MADRAS RECORD OFFICE

G.O. No.	2846	Press
B.P. No.		Mis.
Dated	25 - 10 -	4876
		195

From W. A. GOODCHAP, Esq., District Engineer, Kurnool, to Lieutenant-Colonel J. MULLINS, R.E., Chief Engineer for Irrigation, dated Camp at Cumbum, 30th July 1876, No. 33.

At the request of Major Hasted I have the honor to forward a certified copy of his memorandum on the improvement of the water-supply and drainage of Cumbum Town with sketch.

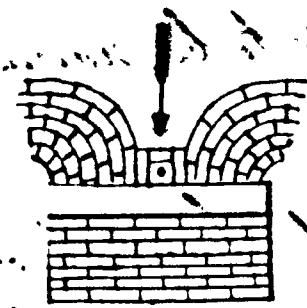
I think it will be well to make arrangements for supplying the Katwa Kalwa channel through the Gundlakamma in dry weather from the head of the Pedda Cumbum channel. There is a sort of escape a little below the sluice, which might probably be converted into a head of supply; where the channel crosses the escape channel from the calingulah a masonry anicut must be constructed over which the escape water can pass in floods. A section something like that shown in the margin would answer the crest of the dam being at full supply level, so that if desirable water can be let down from the Nuckkalagundi sluice to supplement the supply given to the Katwa Kalwa from the Gundlakamma.

to take the surplus from the irrigation under the Nuckkalagundi channel provided. These minor head sluices should be of the simplest description, probably a straight wall with revetments at each end will be as cheap as any thing; something like the sketch in the margin.
